## Presentation to the DC Zoning Commission in Opposition to the Proposed Ladybird, Case 16-23

January 25, 2018

ZONING COMMISSION District of Columbia CASE NO.16-23 EXHIBIT NO.201

Figure 11: Circulation Plan

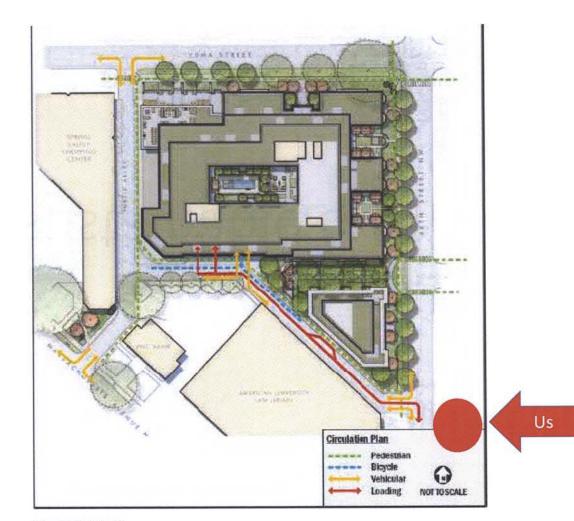
- This is Valor's traffic circulation plan.
- The red circle is where our house is.
- All of the loading traffic will pass in front of our house.
- 370 parking places for vehicles and 305 vehicles/hr at peak
